# Access Compliance Report

## Public Rights-of-Way

Intersection ID: 5563	Main Street: N I-77 EXIT 16 RA	Cross Street: REAMES_RD	Location: NE
ADA ID: F34FE8388DB4	Ramp Type: BlendTrans2	Initial Pass/Fail: Fail	Overall Compliance: No
Severity Score: 10			
Codes/Mitigation Info/Possible Solution		Field Measurements/Component Compliance

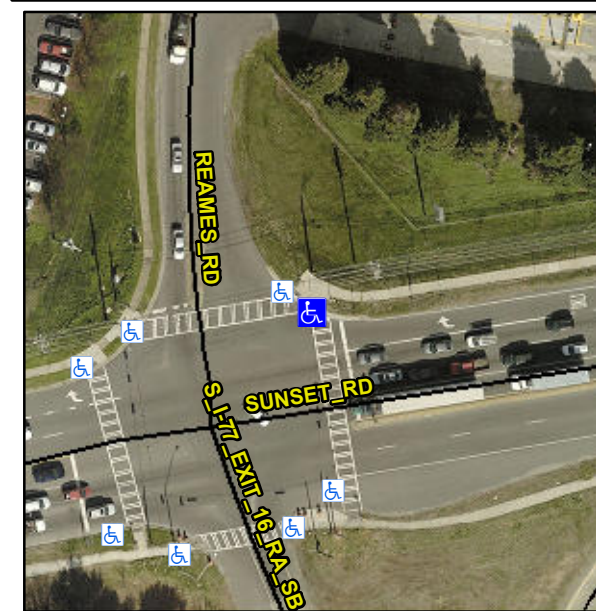
**Remove & Replace Curb Ramp With Two New Directional Ramps or Equivalent.**

**Not Found, R304.5.1**
